PROPOSED PLANS

Project/address: Rear Extension & Alterations
5 Orange Row,
Emsworth,
Hampshire, PO10 7EL

DRAWING: Proposed Plans
Drawing No/rev: C9/0178/05B
Scale: 1:100 @ A3
Date: February 2020

First floor plan | proposed

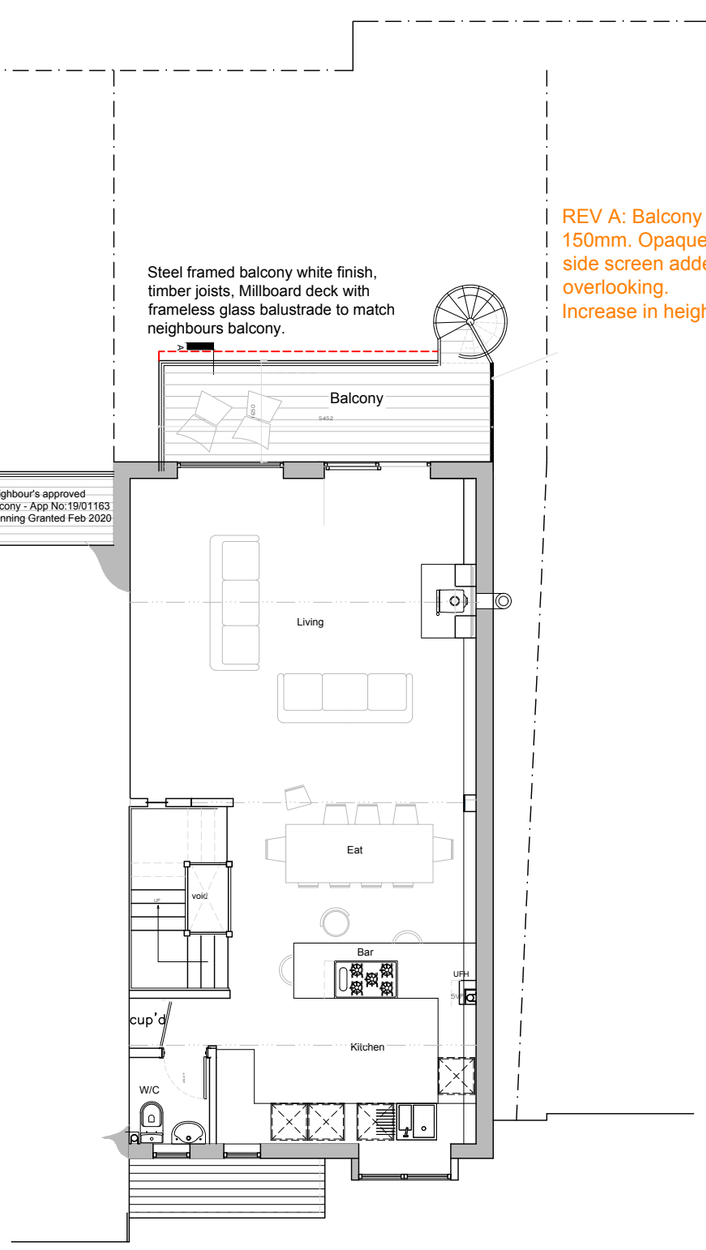
REV A: Balcony reduced in depth by 150mm. Opaque high level (1.8m from ffl) side screen added to prevent sideways overlooking.
Increase in height of 700mm 15-04-2020

Second floor plan | proposed (unchanged as existing)

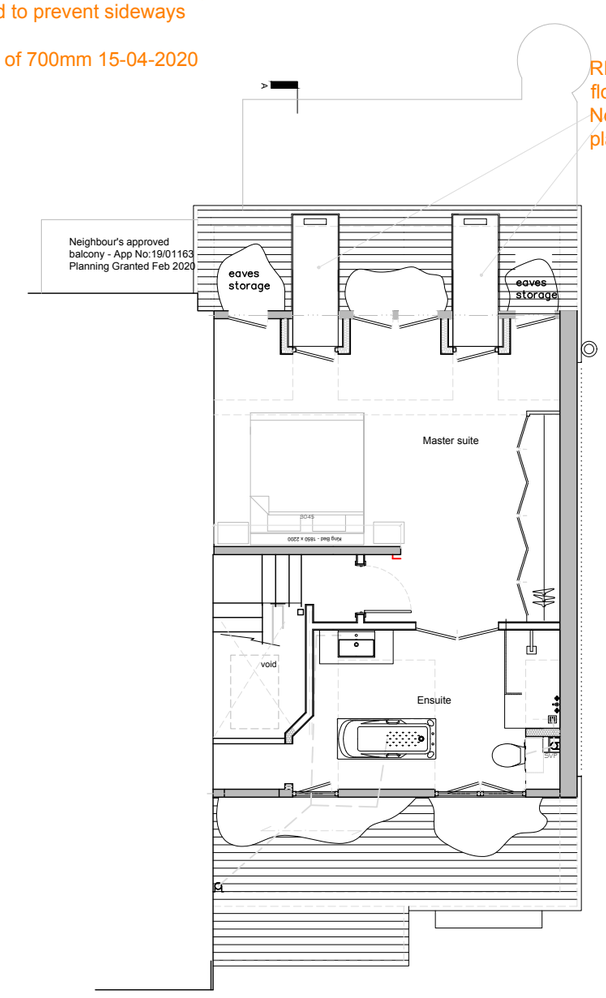
REV A: Balconettes from 2nd floor removed 15-04-2020.
No changes to existing 2nd floor plan.
